Display

Subject: **TWISTED PICTURE**

Model: **BVM-14E1U/14E5U/14F1U/14F5U
BVM-20E1U/20F1U**

Figure 1

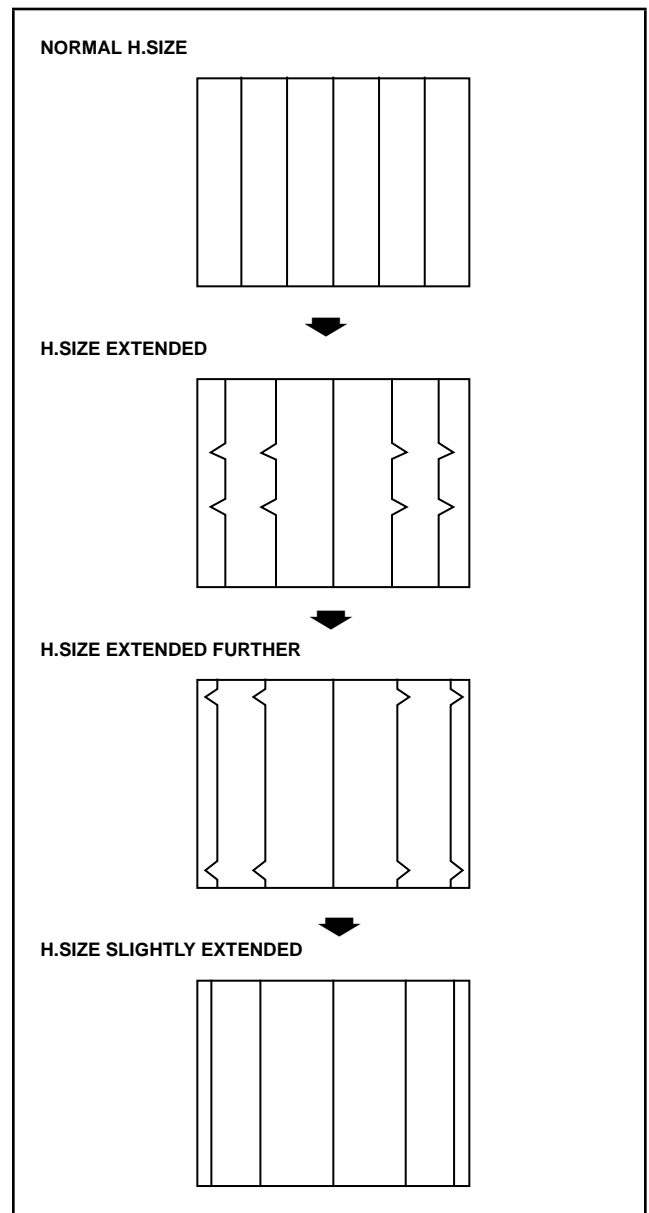
Depending on the values of H.SIZE, H.LIN, or H.LIN BAL, if H.SIZE becomes extended, the picture may appear twisted. (See Figure 1.) If this occurs, or as a preventive measure, perform the following modification.

Figure 2

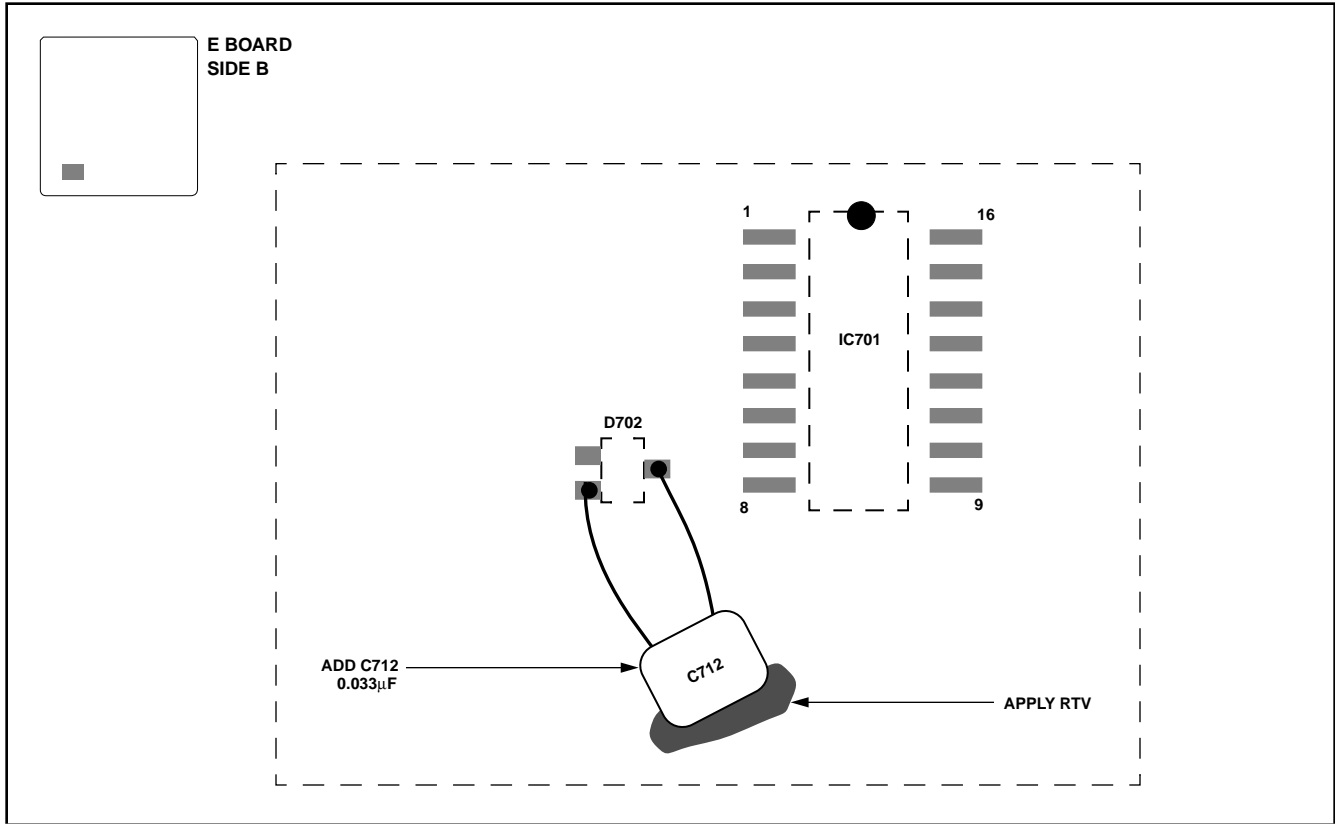
E Board, Side B (See Figure 2.)

1. Solder the new 0.033μF capacitor (C712) between anode and cathode of D702 (zone G-2).
2. Apply RTV to affix the capacitor to the board.
3. Readjust H.SIZE, H.LIN and H.LIN BAL.
